**AGENDA ITEM SUMMARY / STAFF REPORT**  
**FLORENCE PLANNING COMMISSION**

**ITEM TITLE:** PC 21 29 SUB 02 – *Stonefield Investments Tentative Plan with Mods*

**(Proposed) CITY OF FLORENCE  
PLANNING COMMISSION**

**FINDINGS OF FACT (Proposed)  
FLORENCE PLANNING COMMISSION  
EXHIBIT A**

Date: 10/01/2021  
 Project No: 21038.01  
 Drawn By: BMD  
 Checked By: AMB  
 PROPERTY BOUNDARY AND PROPOSED SITE PLAN  
 Sheet title:  
**C2.0**

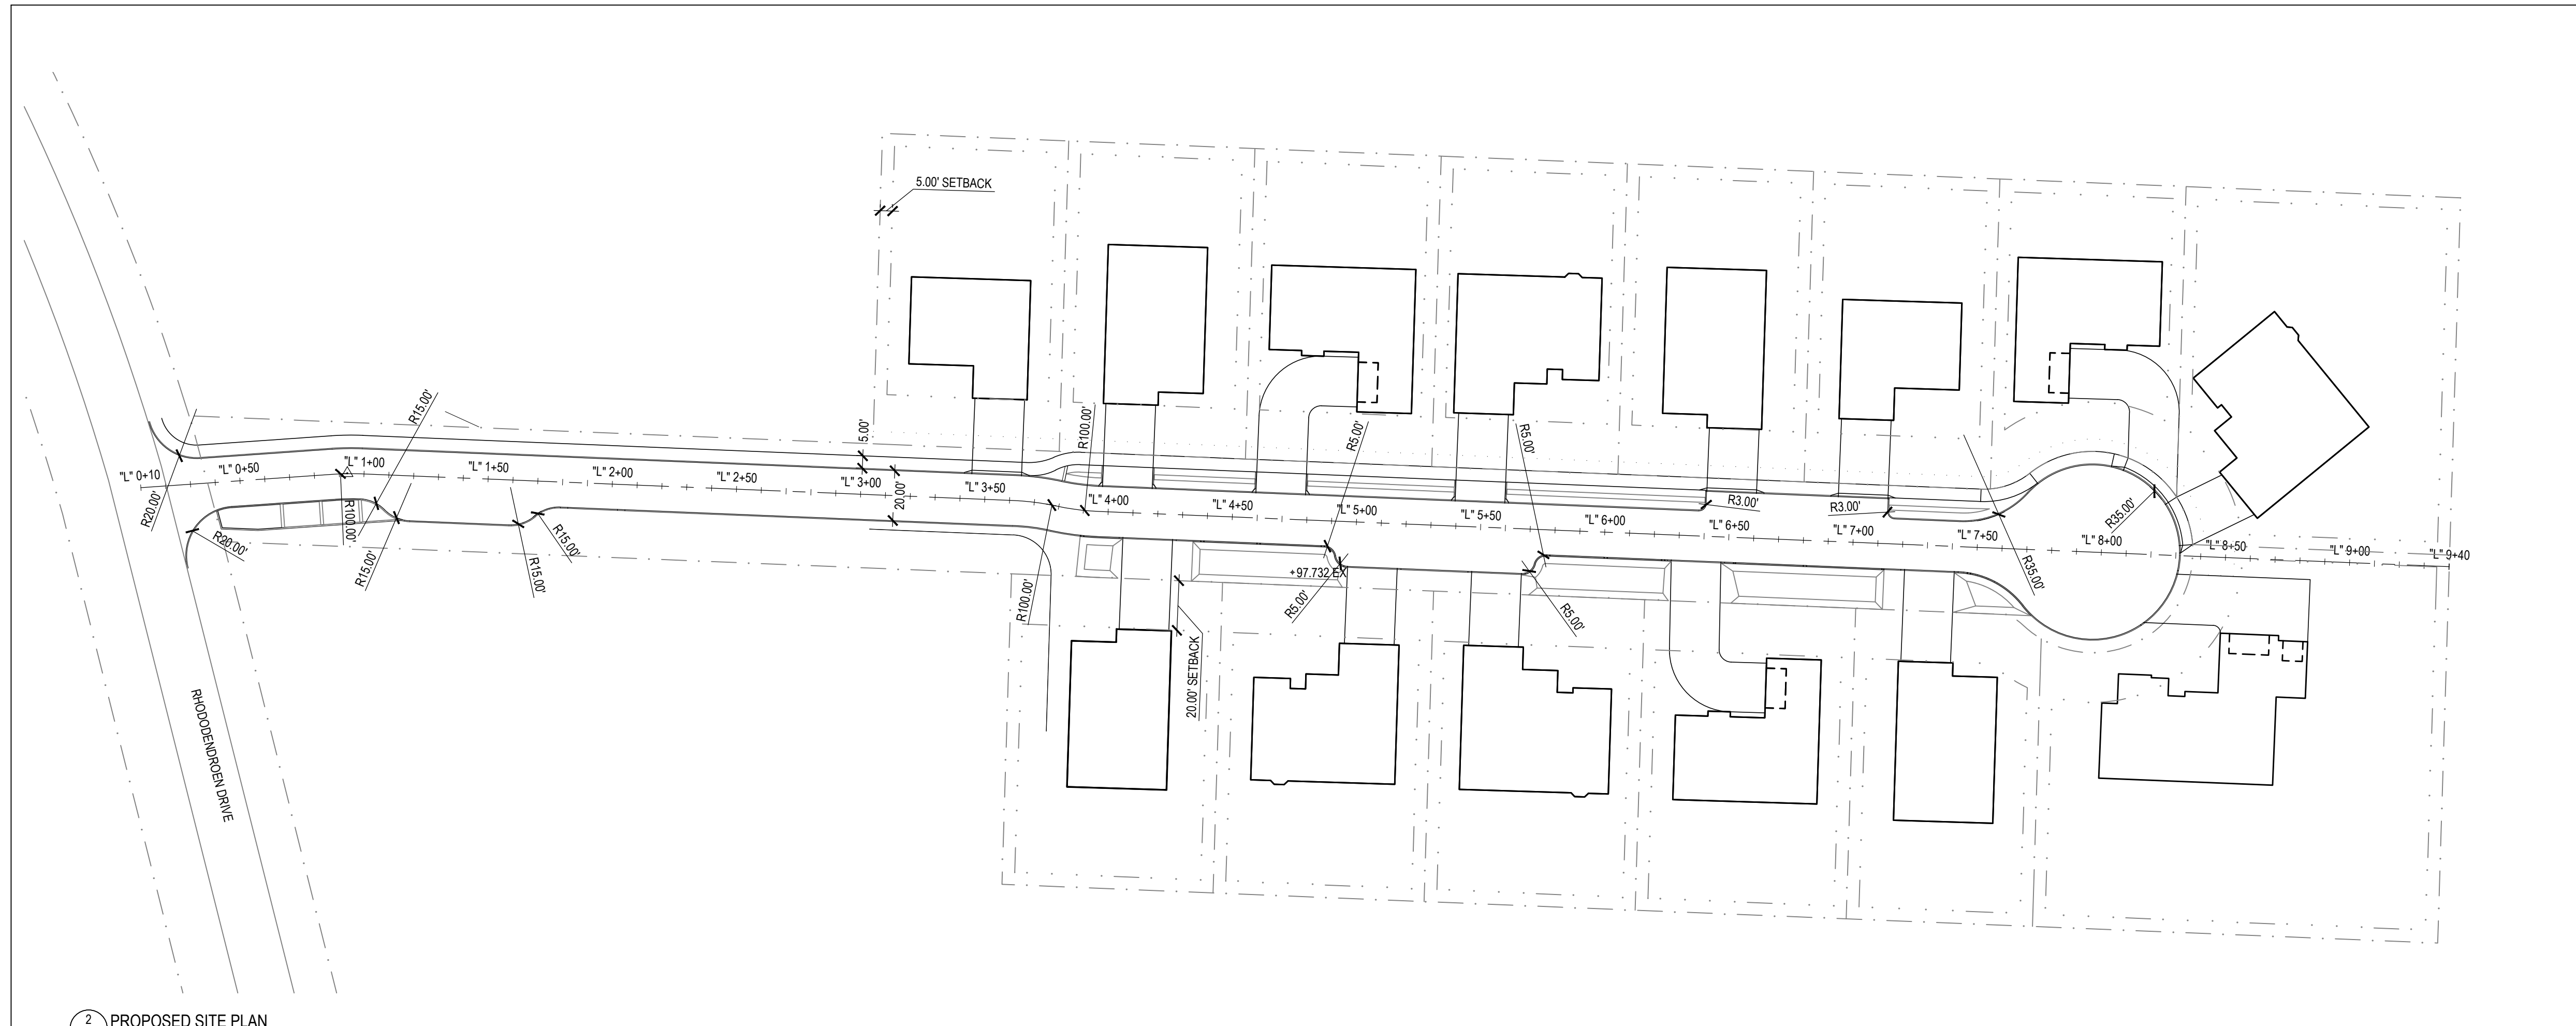
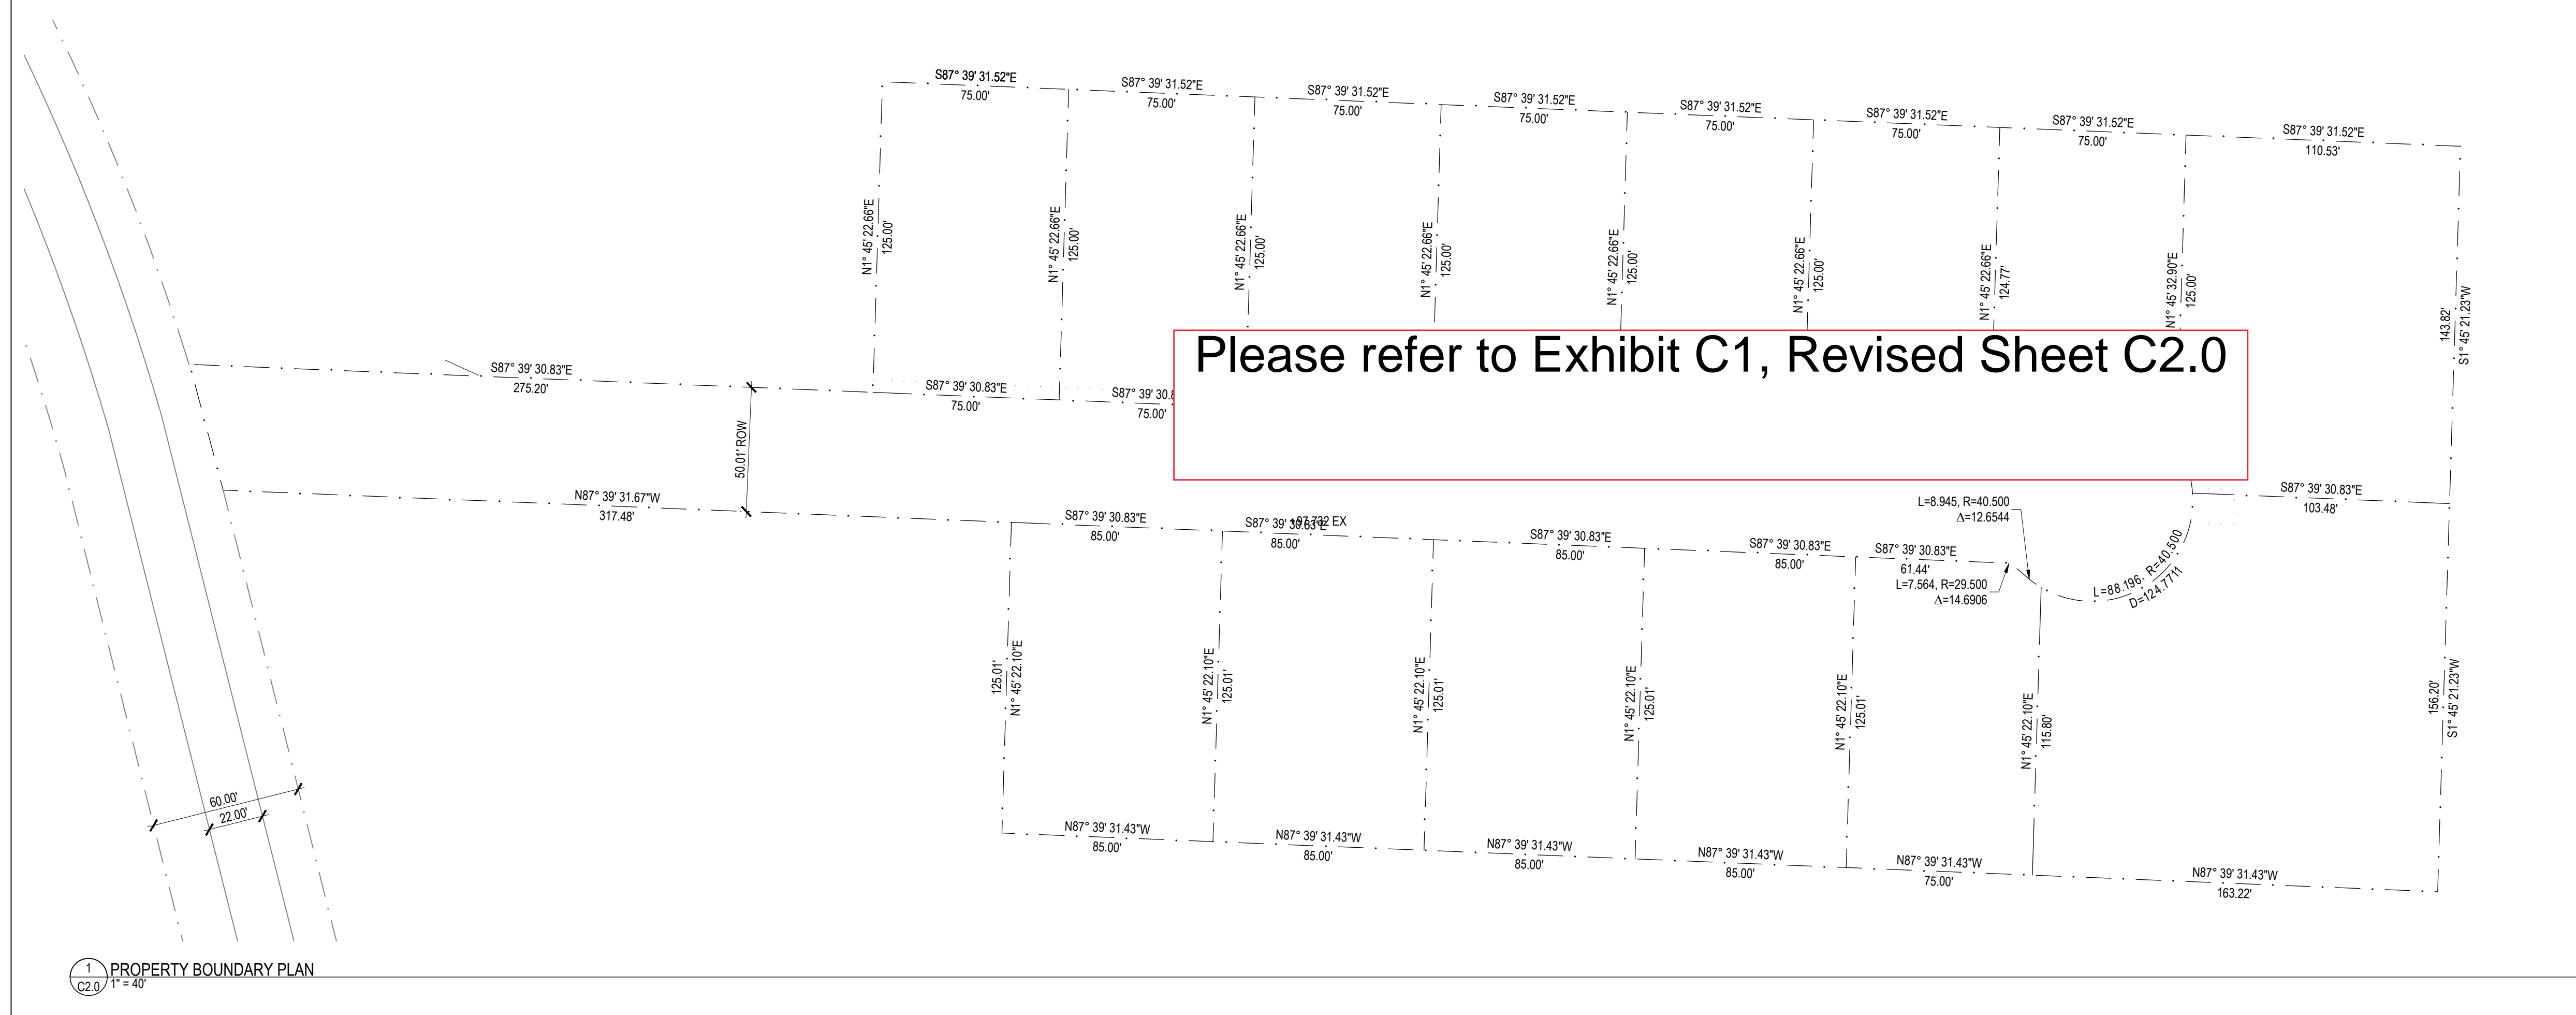
- The sheet C2.0 labels their proposed R-O-W as 50.01’ rather than 50.00’. This is likely inconsequential but warrants further checks on dimensioning as they’re probably being automated by CAD.*
- Related to the above comment, I was under the impression that the City’s minimum R-O-W width is 60’. I’m unsure whether the development is proposed as entirely private, or if the R-O-W will be the City’s. Otherwise, the street and lot layout appear to meet setback and fire access requirements.*

FINDING: As seen on the tentative subdivision plat (Exhibit B, Sheet C2.0), all proposed lots have at least a width of 50-feet and a depth of 80-feet. The dwelling units will all be single-family detached units. Criterion met.

**FINDING:** As seen on Sheet C2.0 of Exhibit B, all lots are above the minimum lot area of 5,000 square feet for a single-family detached dwelling in the MDR zone. Criterion met.

FINDING: The location and width of the proposed street to be constructed to serve the subdivision is shown on Sheet C2.0, Exhibit C. The proposed street, as shown on the Tentative plan is 50.01-feet wide. The adjacent Rhododendron Drive, is shown on the Tentative plan and contains a right-of-way width of 60-feet. There are no existing or planned streets from previous subdivisions or major partitions for which the proposed street to serve the subdivision can conform to. The applicant has applied to City Council for a deviation from the street naming conventions in the City of Florence. The naming of the street, in accordance with local and County standards will be a condition of approval and further addressed in this report, as applicable.

FINDING: The boundary of the area is shown and described on the Tentative plan (Sheet C2.0, Exhibit B). The applicant provided a legal description of the property but it is not included on the tentative plan. The final plat that is prepared shall contain a legal description in accordance with ORS 92. **(Condition 17)**.

- The sheet C2.0 labels their proposed R-O-W as 50.01' rather than 50.00'. This is likely inconsequential but warrants further checks on dimensioning as they're probably being automated by CAD.

- 5.a** The street to be constructed will be a local street, as such sidewalks must be provided on at least one side of the street. As seen on Sheet C2.0 of Exhibit C, sidewalks are proposed along the northern side of the street and to be 5-feet wide. Sidewalks must be in conformance with construction standards of FCC 8-2-3. Plans for sidewalk construction shall first be reviewed and approved by the Florence Public Works Department, prior to the issuance of building permits. If the limited street width on the entry pan handle (50 ft. wide) is not wide enough after providing the required pavement width, utility service area and stormwater facilities, one side walk may be permitted. If this is the case then a demarcated walkway shall be provided at the east end of the street stem between Lots 1 and 2 to connect pedestrians with the remaining sidewalk serving Rhododendron Dr.

- 12.a** The date, north arrow and scale are shown on the tentative plan. The location of the proposed subdivision is provided under the tentative plan's title. North Leeward Estates is a subdivision contiguous on the east side of this proposal. The final plat application shall contain the names of contiguous subdivisions, such as North Leeward Estates. Furthermore, what are labeled Parcels on revised Sheet C2.0 in Exhibit C1 shall be relabeled as Lots on the final subdivision plat draft.

- 17.** The boundary of the area is shown and described on the Tentative plan (Sheet C2.0, Exhibit B). The applicant provided a legal description of the

Comment: Civil West’s observation regarding the minimum ROW is correct. The reason this Tentative plan is being reviewed by the Planning Commission is due to modification requests; one of which pertains to reduced ROW width. The Planning Commission will decide if the request for the reduced width will apply to a segment of or the entire new street. The street will be public.

PROPOSED GRADING & CUT FILL PLANS  
 Sheet title:  
**C3.0**

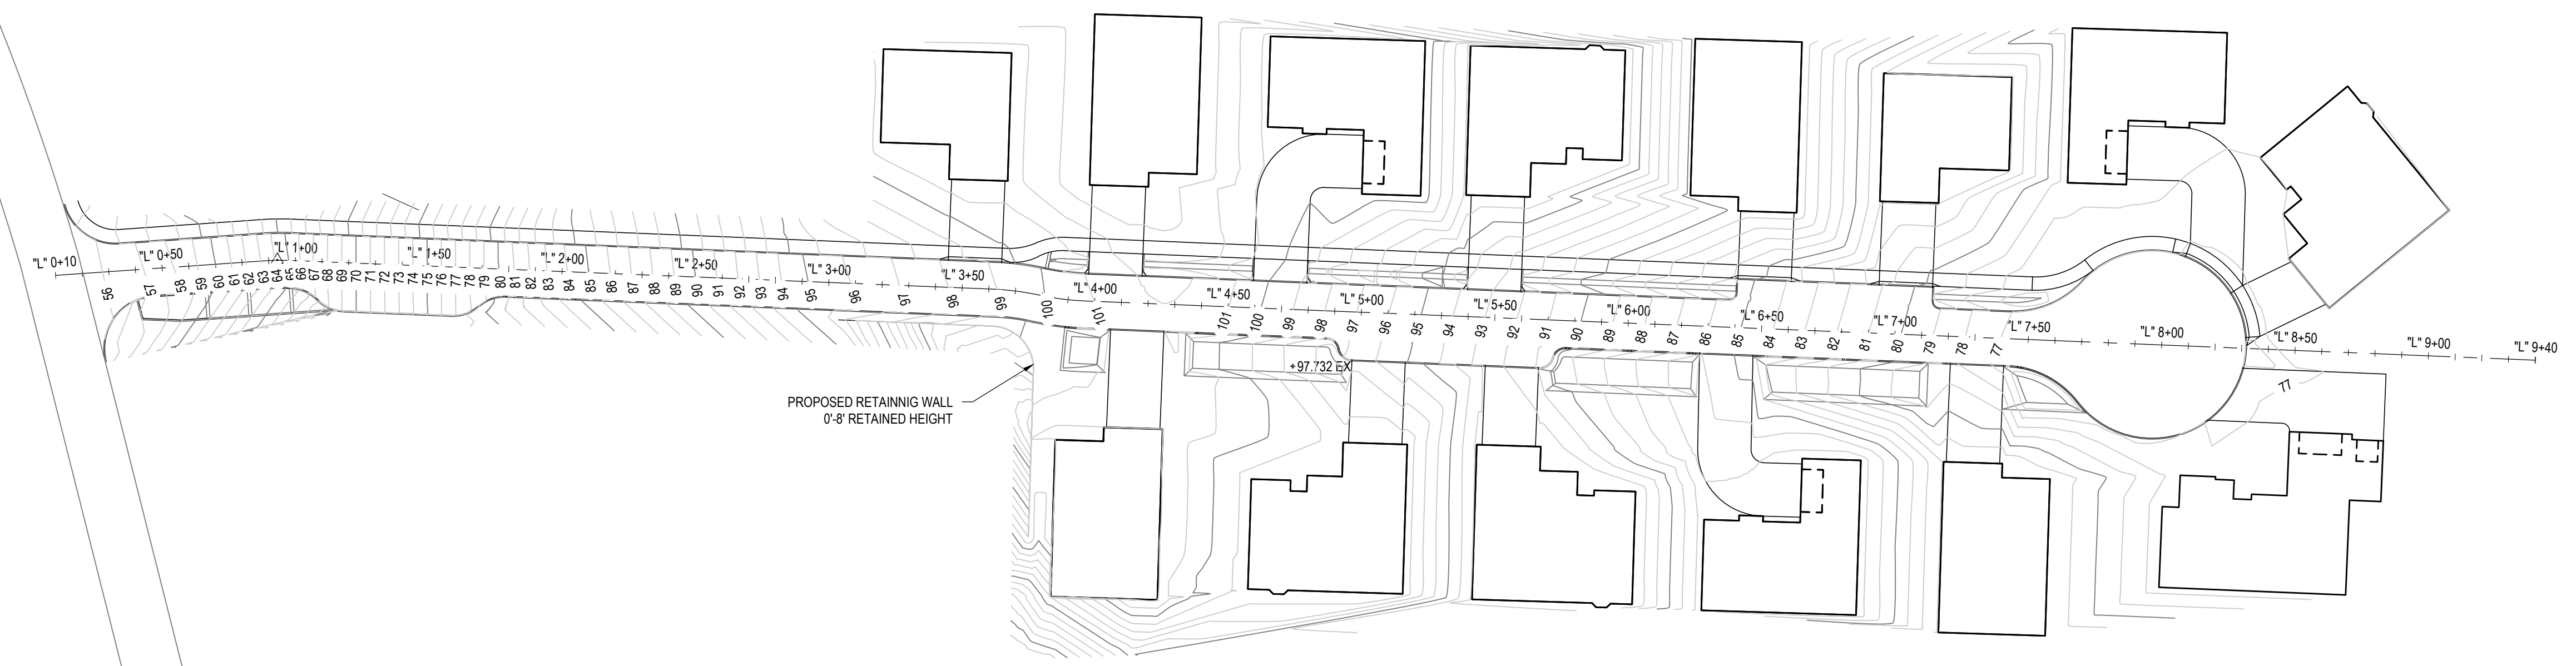
- *Sheet C3 displays cuts and fills along with proposed grading structures. They show a proposed 0-8' retaining wall on the southwest side of the development where cuts and fills appear to vary greatly. This is fine, provided more information is provided; however, there appear to be large cuts along eastern edge, and we'll need more information on how these are going to be managed/contained, especially with the behavior of the sandy soils in the area.*

- *The provided contours on Sheet C3 indicate that drainage will flow from the peak contour of 101' back onto City Streets. The applicant will need to show how all stormwater will be treated and managed on-site.*

- Otherwise, the street and lot layout appears to meet setback and fire access requirements.
- Sheet C3 displays cuts and fills along with proposed grading structures. They show a proposed 0-8' retaining wall on the southwest side of the development where cuts and fills appear to vary greatly. This is fine, provided more information is provided; however, there appear to be large cuts along eastern edge, and we'll need more information on how these are going to be managed/contained, especially with the behavior of the sandy soils in the area.

- The provided contours on Sheet C3 indicate that drainage will flow from the peak contour of 101' back onto City Streets. The applicant will need to show how all stormwater will be treated and managed on-site.

- 15.** The applicant's materials were reviewed by the City's contract engineering firm, Civil West Engineering. In their comments, Civil West notes that Sheet C3 displays cuts and fills along with the proposed grading plan. The applicant shows a proposed 0-8' retaining wall on the southwest side of the site where cuts and fills appear to vary greatly. Civil West indicates the proposed cuts and fill plan is acceptable provided that more information is provided. The contract City Engineer will require more information on how the cuts and fills are going to be managed and contained, especially with the behavior of the sandy soils present in the area. A final grading and cut and fill plan shall be required to be reviewed and approved by the contract City Engineer, before the issuance of public infrastructure permits.

- 16.** Sheet C3 also indicates that drainage will flow for the peak contour of 101' back onto city streets. The applicant has not shown how all stormwater will be treated and managed on site. This will be a condition of approval, prior to the issuance of public infrastructure permits.

FINDING: The applicant's materials were reviewed by the City's contract engineering firm, Civil West Engineering. In their comments, Civil West notes that Sheet C3 displays cuts and fills along with the proposed grading plan. The applicant shows a proposed 0-8' retaining wall on the southwest side of the site where cuts and fills appear to vary greatly. Civil West indicates the proposed cuts and fill plan is acceptable provided that more information is provided. The contract City Engineer will require more information on how the cuts and fills are going to be managed and contained, especially with the behavior of the sandy soils present in the area. A final grading and cut and fill plan shall be required to be reviewed and approved by the contract City Engineer, before the issuance of public infrastructure permits. **(Condition 15)**.

Sheet C3 also indicates that drainage will flow for the peak contour of 101' back onto city streets. The applicant has not shown how all stormwater will be treated and managed on site. This will be a condition of approval, prior to the issuance of public infrastructure permits. **(Condition 16)**.

FINDING: The applicant has submitted a preliminary grading plan, as seen on Sheet C3.0 of Exhibit C. A final grading plan will be required as a condition of approval. The final grading plan is subject to review and comment by Public Works and/or Engineering.
